Title:	Flush Gate Motors			ID:
				148
30.11.16	Response:	Model:	Author:	
		-	CMA

Flush-Gate Motors

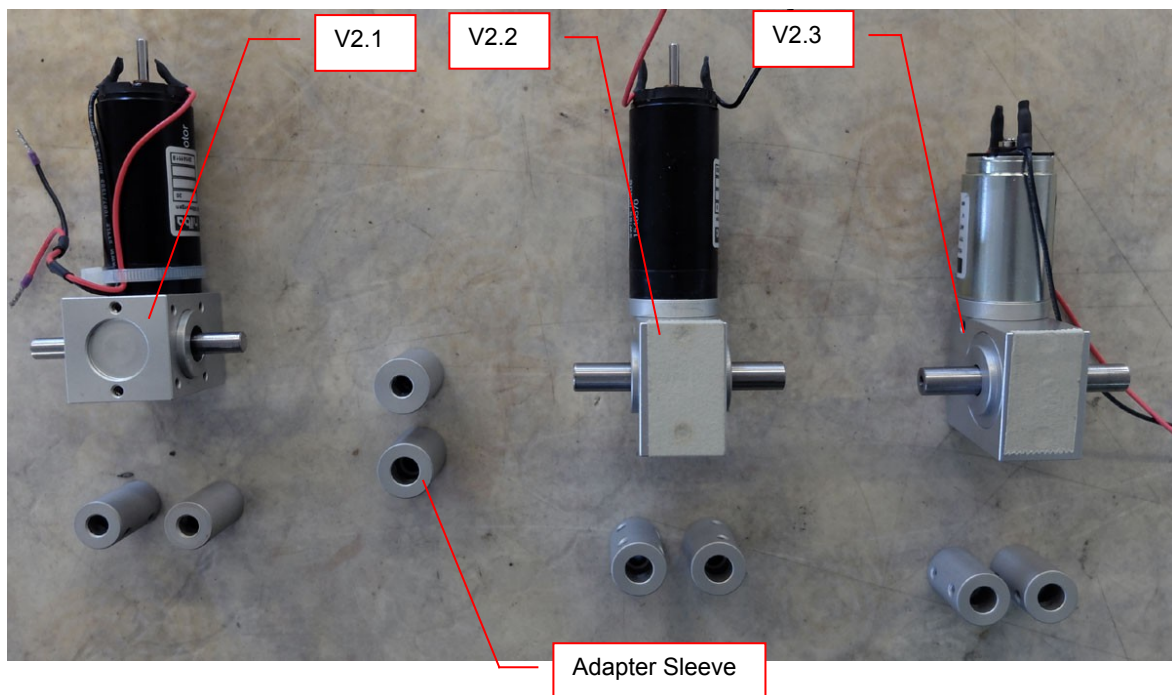
There three versions of Flush-Gate motor-gearbox combination: V2.1, V2.2, V2.3. The gearboxes have some incompatibilities

- ! Diameter of axis V2.1: 8mm, V2.2 and V2.3: 10mm
- ! Attachment holes and outer dimensions V2.1 differ from V2.2 and V2.3

Version 2.2 and V2.3 are interchangeable. To replace a version 2.1 motor-gearbox two Adapter Sleeves are required.
